UNITED STATES PATENT AND TRADEMARK OFFICE

APPLICATION NO.	FILING DATE	FIRST NAMED INVENTOR	ATTORNEY DOCKET NO.	CONFIRMATION NO.
10/002,049	11/02/2001	Charles F. Malone	KPF / 54	4375

# Office Action Summary

### **DETAILED ACTION**

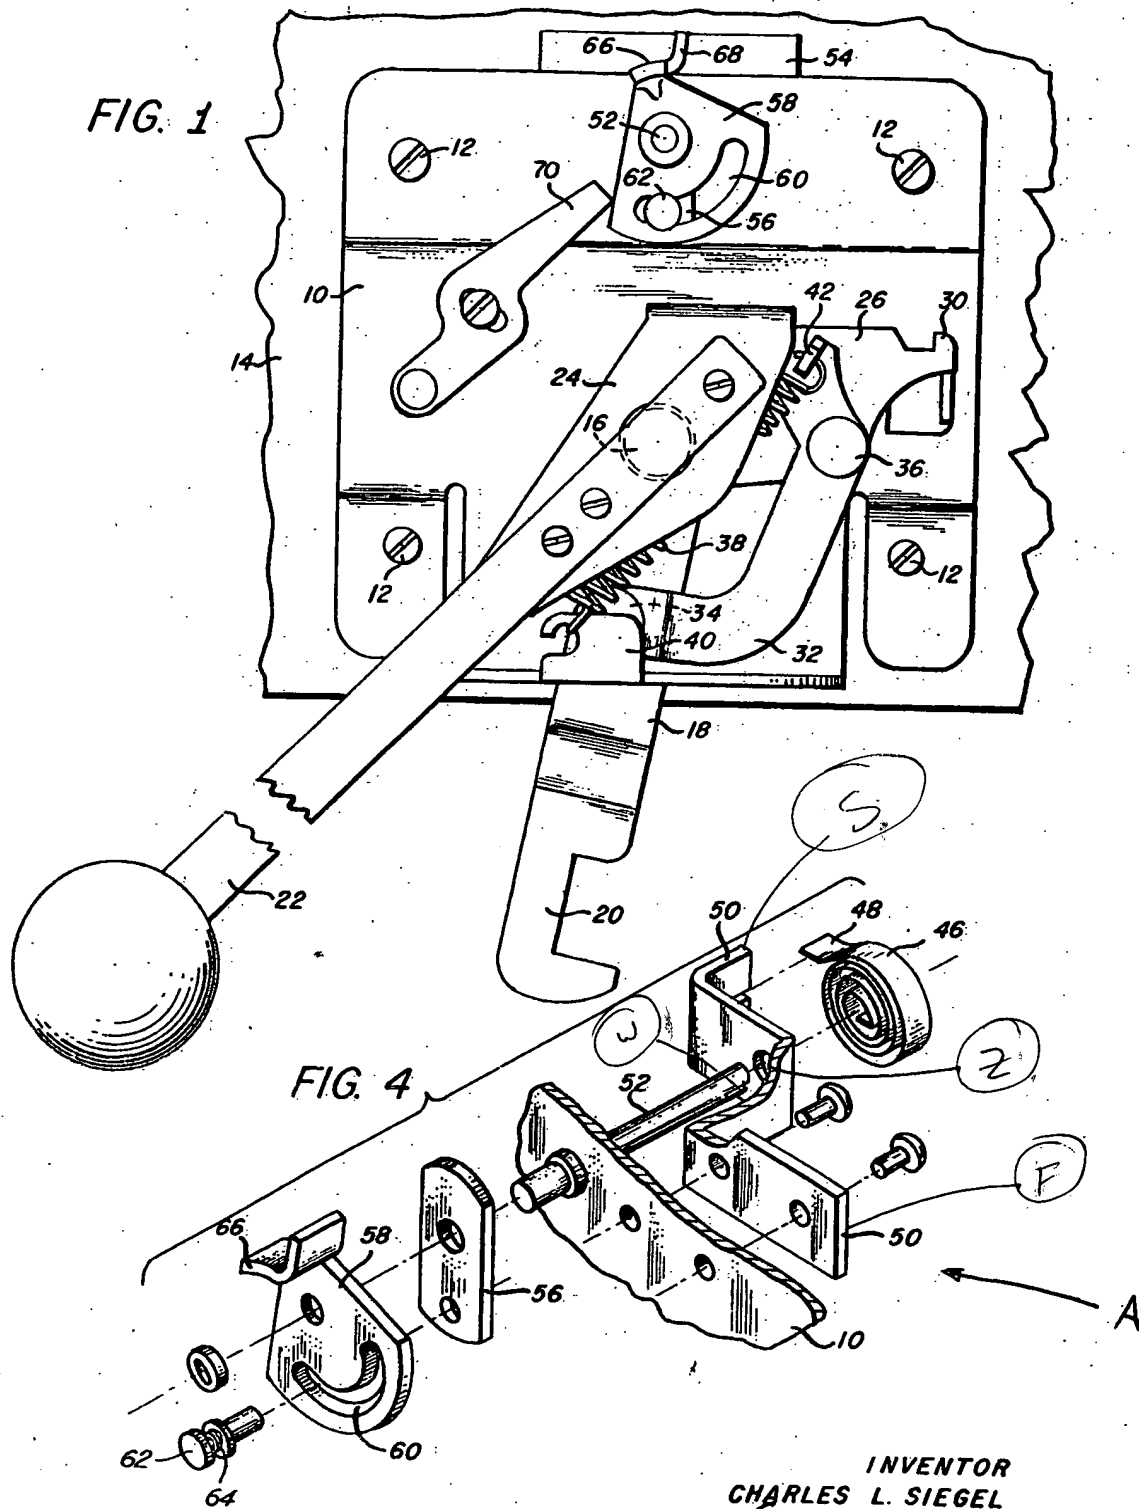
defines encompass as to “include”, and as shown in Fig. 4, Siegel’s first spring includes lock member (50) via pin (62). In regards to claim 12, Siegel’s slot (W) is elongated, see Fig. 4. As it concerns claim 13, Siegel’s oven door locking mechanism further comprises a latch mechanism defining a lock hole (generally H in Fig. 3) adapted to receive said lock member, see Fig. 3; and a mounting bracket (10) wherein said first spring is affixed to said mounting bracket via pin (62). In regards to claim 14, Siegel’s thermally responsive element is a bimetallic leaf secured at a first end (48) and defining said slot at a second end; see col. 3, lines 54-55. Regarding claim 15, Siegel’s lock hole comprises a receiver member (R), see Fig. 3. As it concerns claim 16, Siegel’s receiver member is a bushing. For the purposes of clarification, the *Merriam-Webster’s Collegiate Dictionary* 10<sup>th</sup> Edition defines bushing as “a mechanical part used to... serve as a guide”. Claim 17 is rejected as set forth above. In regards to claim 19, Siegel discloses an oven door locking mechanism which locks the oven door at a temperature substantially higher than that at which it unlocks the oven door as set forth above. The Examiner notes that Siegel’s oven inherently has a substantially uniform temperature between the oven air and the oven door locking mechanism and since the applicant has not claimed any structure the further limit the oven door locking mechanism, the recitation has not been given any patentable weight. In regards to claim 20, Siegel comprises a thermally responsive element (46) capable of actuating locked and unlocked states of the oven door at different temperatures as set forth above.

5. The Examiner notes that Siegel and Fox were provided with annotations to accurately communicate to the applicant the specific structures the Examiner was referring to in the rejections. For the applicant's benefit, the Examiner has attached the appropriate figures to this Office Action.
